—
P21110-FCH-XX-XX-RG-A-0003
PLANNING APPLICATION PROPOSED AMENDMENTS - OVERVIEW
APPLICATION REF: 120149/FO/2018

Planning Application Proposed Amendments - Overview

DUCIE STREET, MANCHESTER

This document provides an overview of proposed variations to the planning consented scheme '120149/FO/2018'.

Item 09. Minor amendment to soldier coursing on Ducie Street Elevation Ground Floor

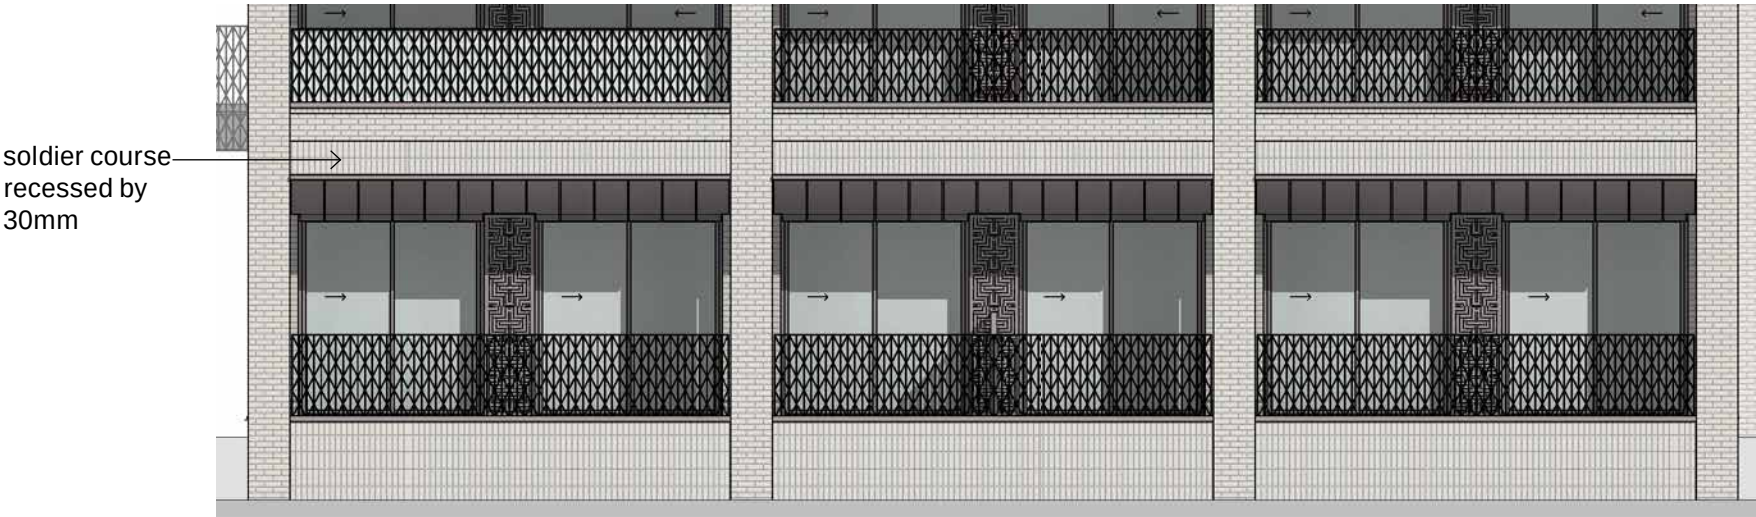
It is proposed to marginally reduce extent of the soldier coursing due to complications in installing the masonry support and achieving tolerances on the structural frame.

This means that the soldier coursing in this location would need to be recessed by 30mm in order to maintain suitable bedding onto the masonry support.

Since we have 30mm recessed brickwork elsewhere on the project it is felt that this ties in with current design language. It would also offer visual relief to the planar elevation, enhancing it's appearance.

The original proposal wrapped the soldier coursing around the corners and across the vertical piers - however our opinion is that limiting the recessed soldier coursing to above the balcony openings enhances the vertical proportion of this facade and the legibility of the balcony openings.

Proposed Metal Balustrade - Recessed Balcony (nts)

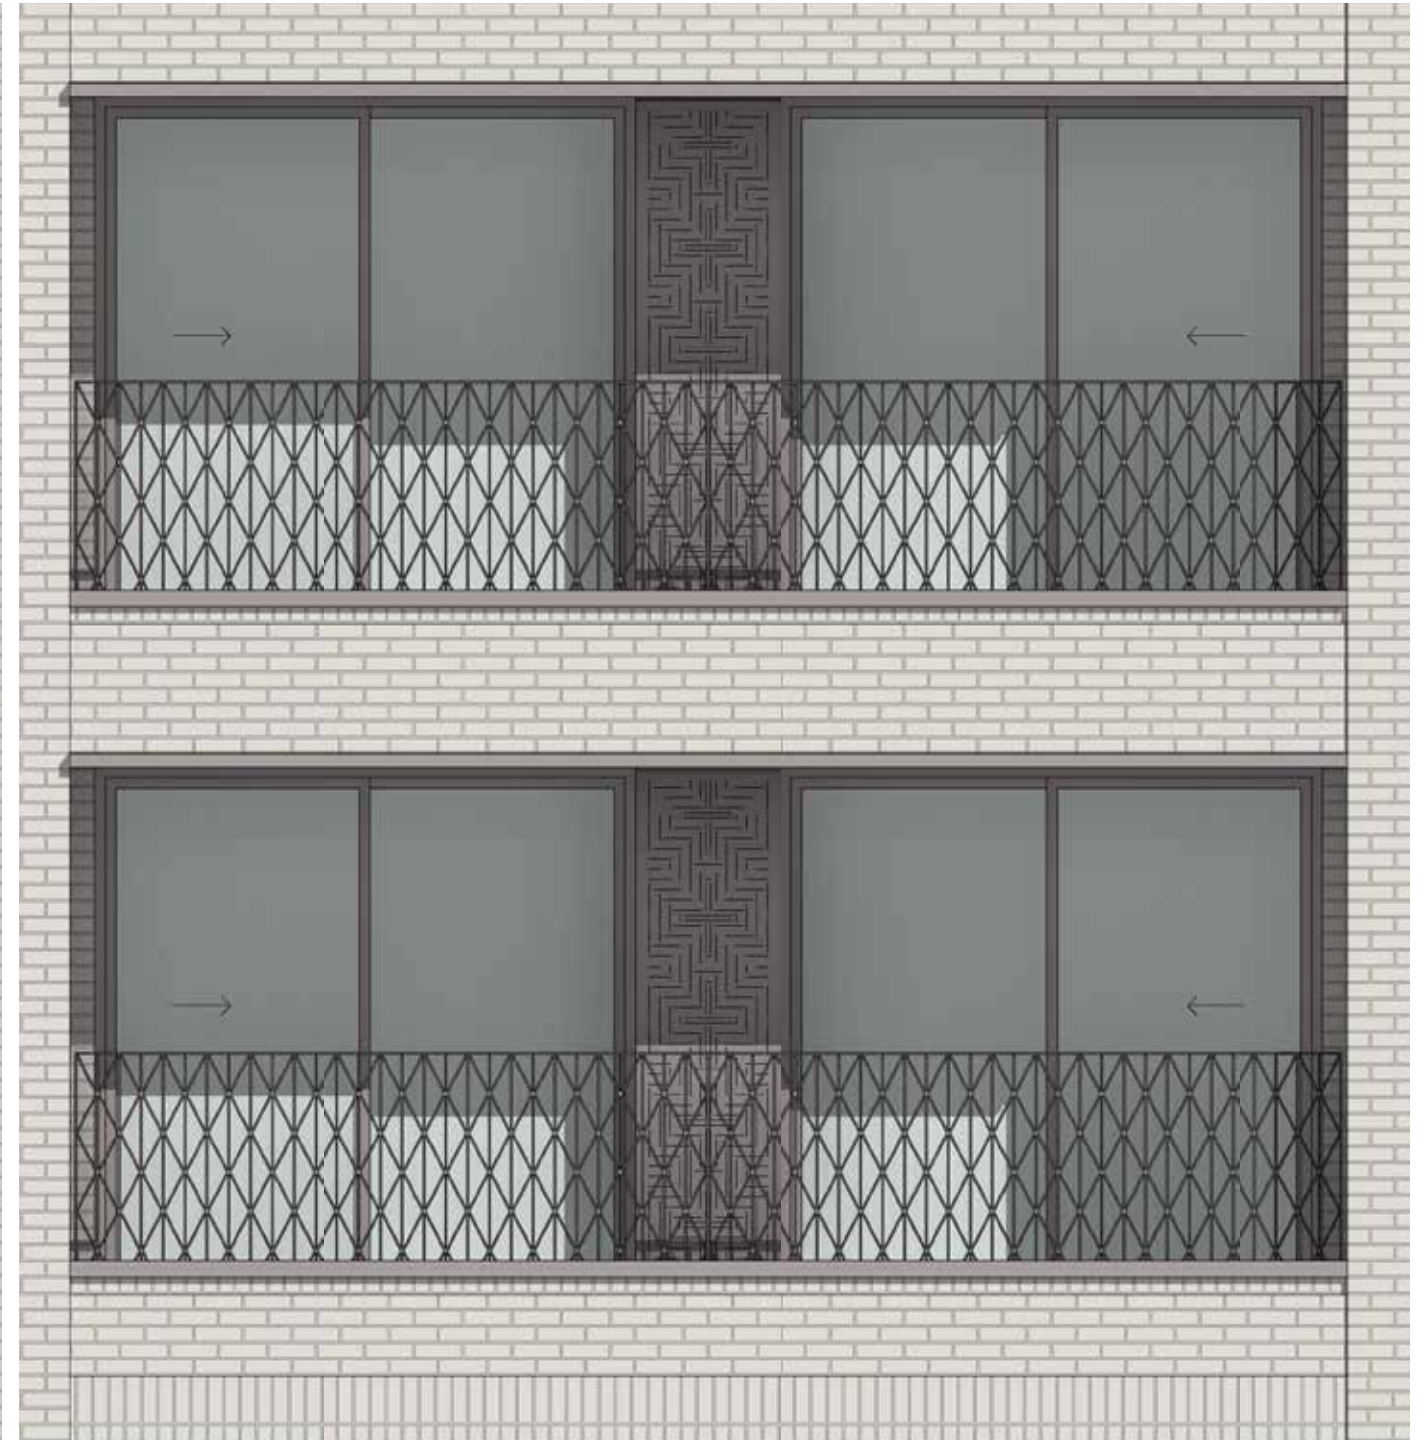
Option 03 was preferred, striking a suitable balance of detail and decoration without overloading the overall building appearance. It was felt to have more direct reference to the diamond motif without directly repeating the perforated panel pattern.

In the final development of this proposal we chose to omit the horizontal bars, which improved the legibility of the diamond pattern whilst also improving the visual permeability.

The images adjacent illustrate how the proposed railings would look on the 3no. different balcony types. The proposed railing would also be used behind the mid-height parapet wall on the Level 07 roof terrace - replacing the approved flat-metal bar railings.

PERFORATED PANEL - JOINT OPTIONS

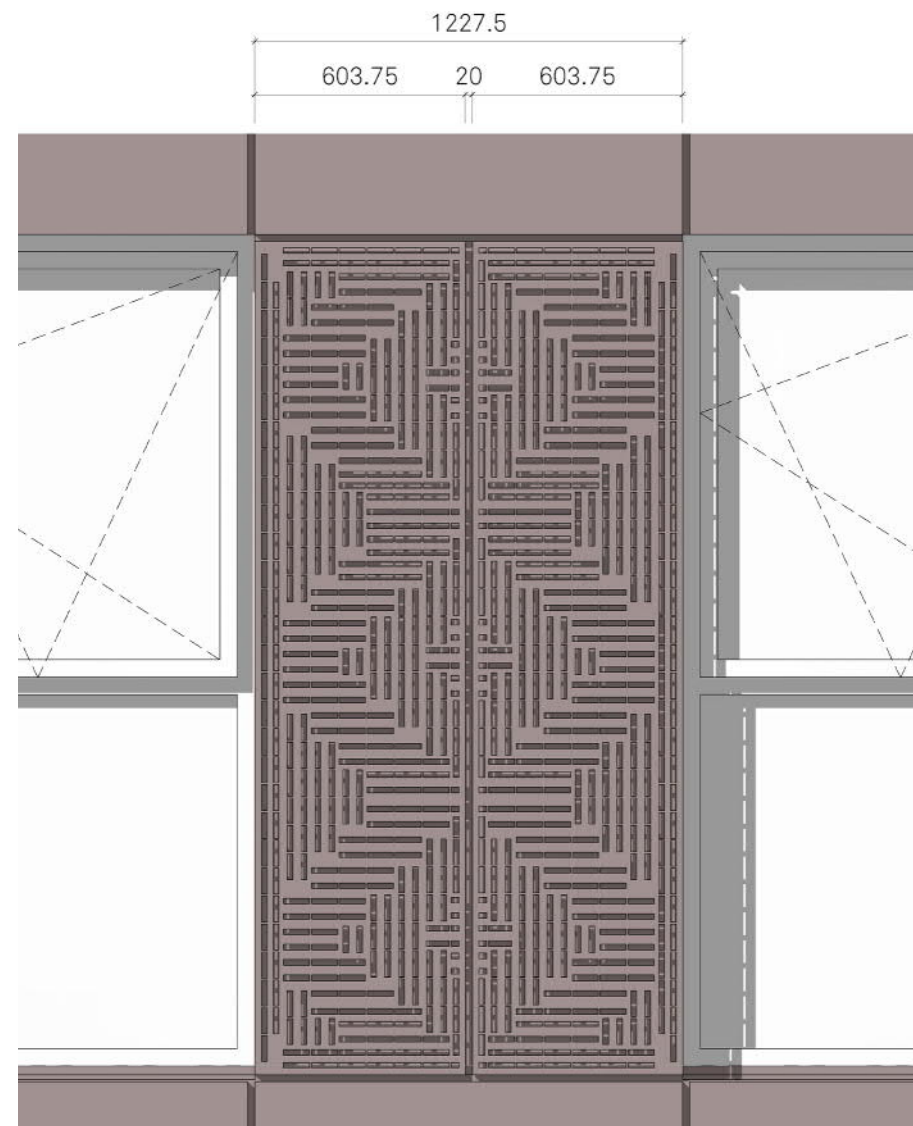
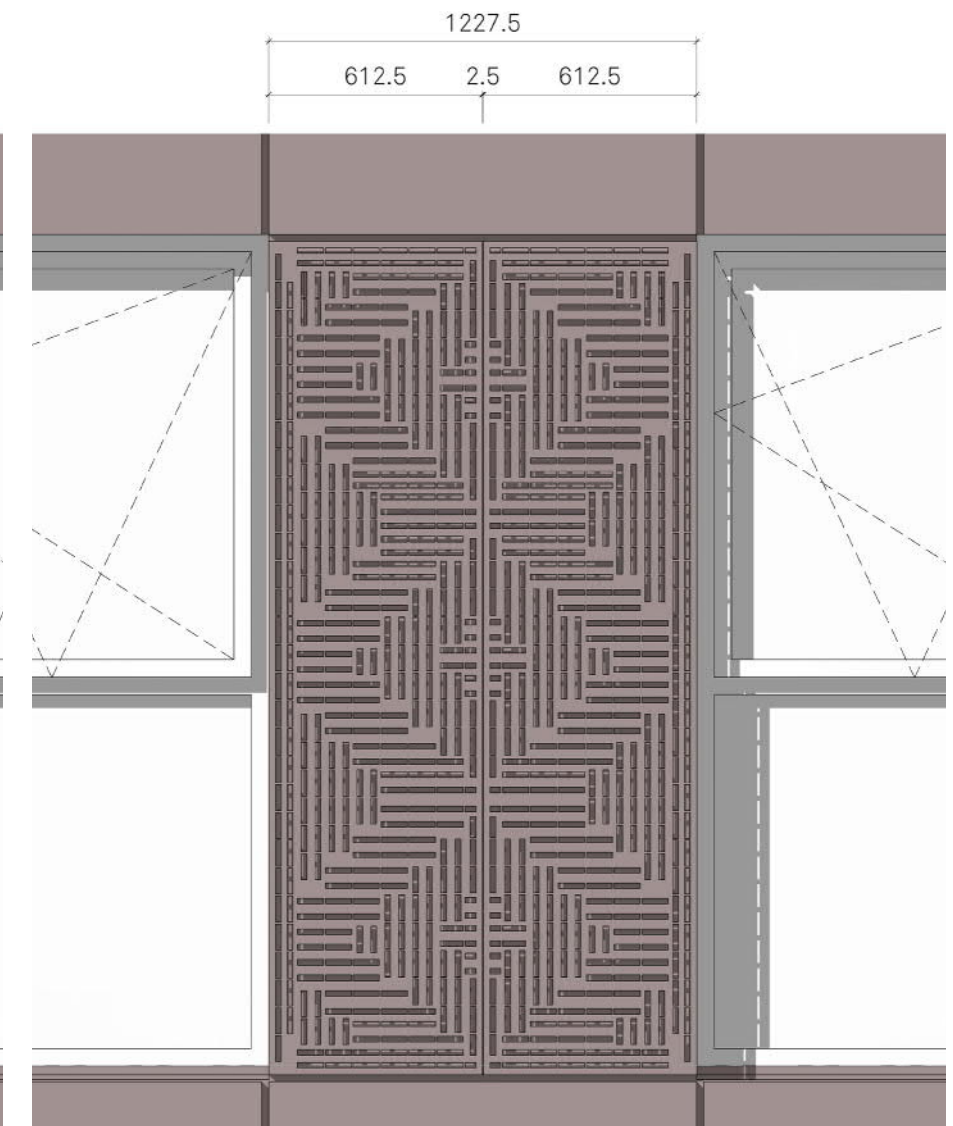
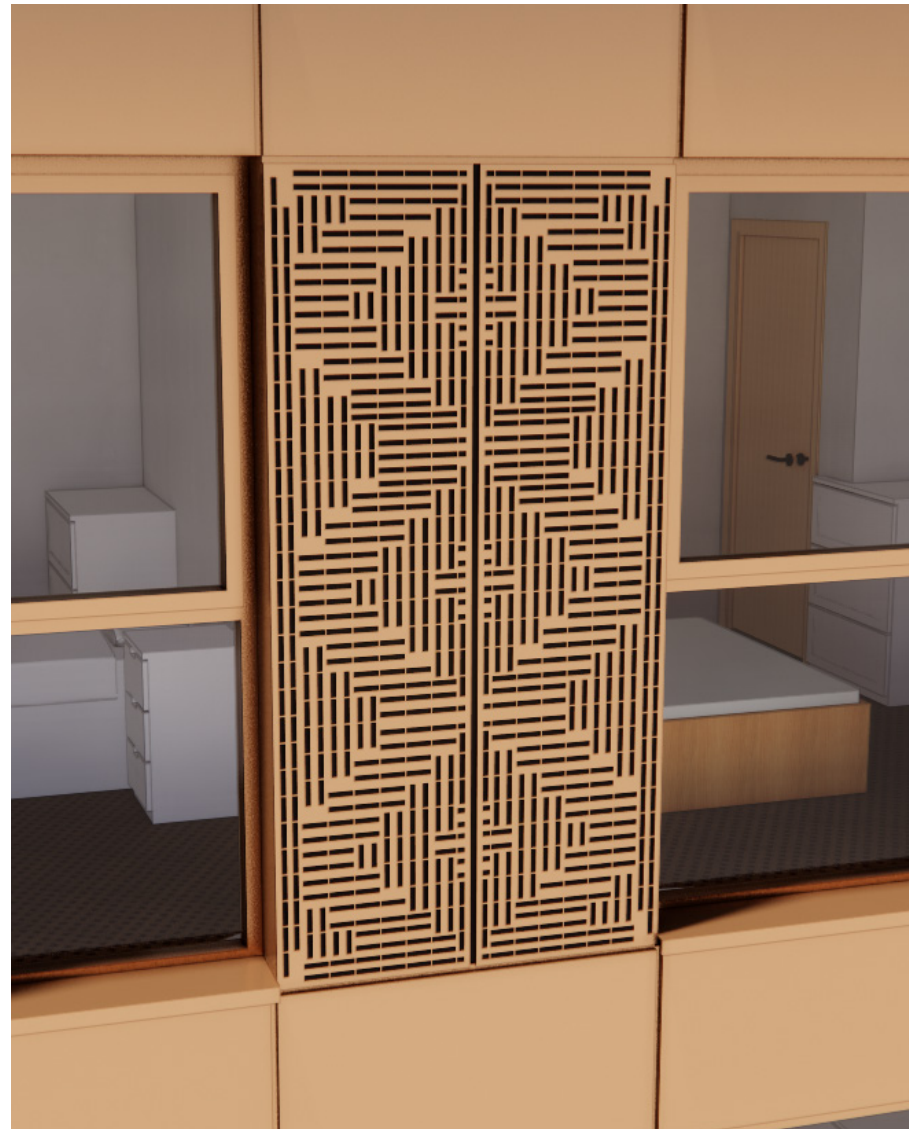
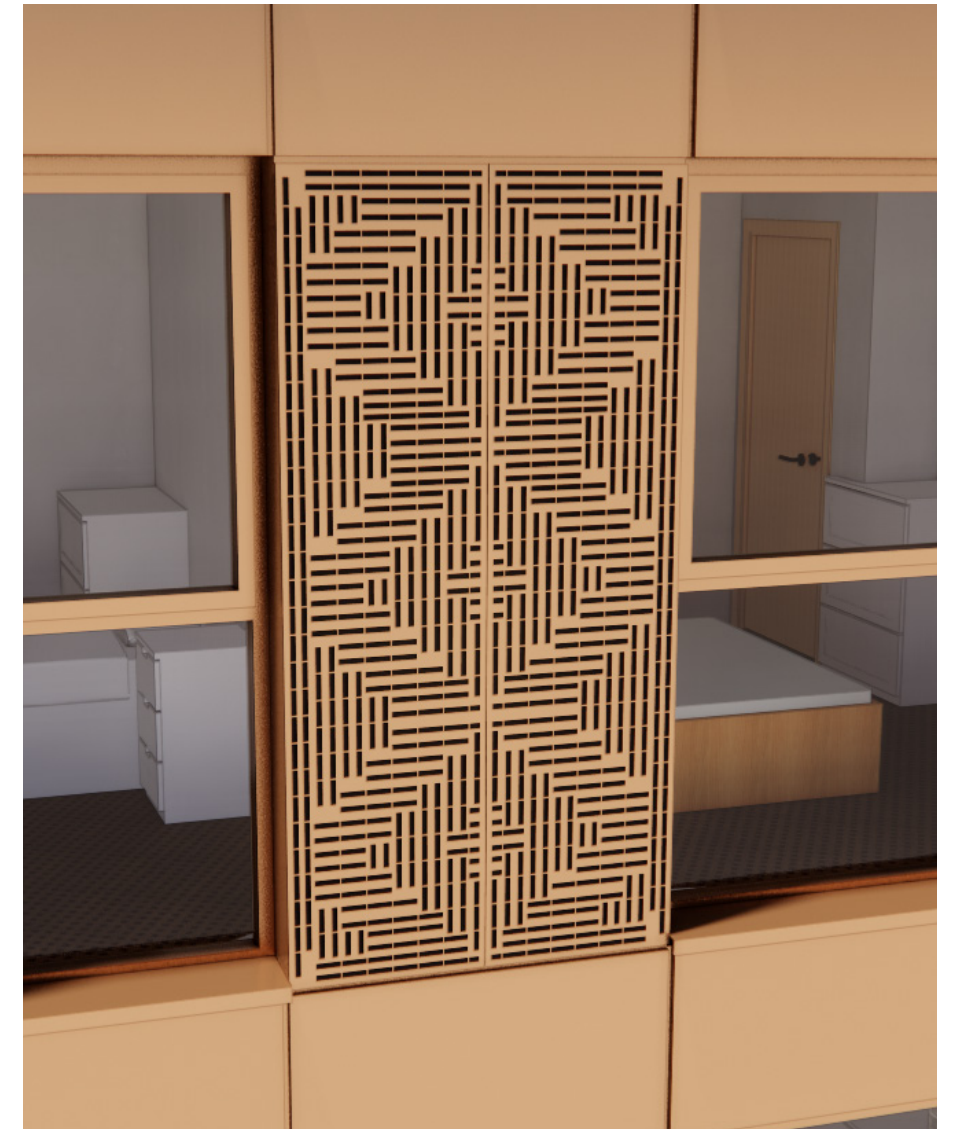
As part of the technical development of the design for the metal cladding, the fabricators have advised that the perforated panels must be limited in width to 1525mm. This is due to the maximum flat sheet size, clamping area and panel returns. A number of the perforated panels in the approved design exceed this limit, therefore we need to consider splitting them into two slimmer panels.

This joint has been developed to mimic the perforations of the panels and blend within the pattern. This has been explored by replicating the width of the perforations for the joint to camouflage the seam with the perforations.

This joint has been developed to reduce the visibility of the seam between the newly split panels. This has been explored by reducing the width of the joint to reduce the visual impact of the seam.

While this joint is the most visually prominent of the two, the similar width of the seam to the size of the perforations allows the junction between the panels to blend in with the pattern of the perforations quite effectively.

While this join reduces the size of the junction, the pattern of the perforations and the required 19mm clear area to the edge of the panel results in a more noticeable seam between the panels.

The 20mm joint was the preferred option, providing a solution which integrates well into the pattern of the perforations.

This joint type also reduces the visual impact that this change will have on the elevations.
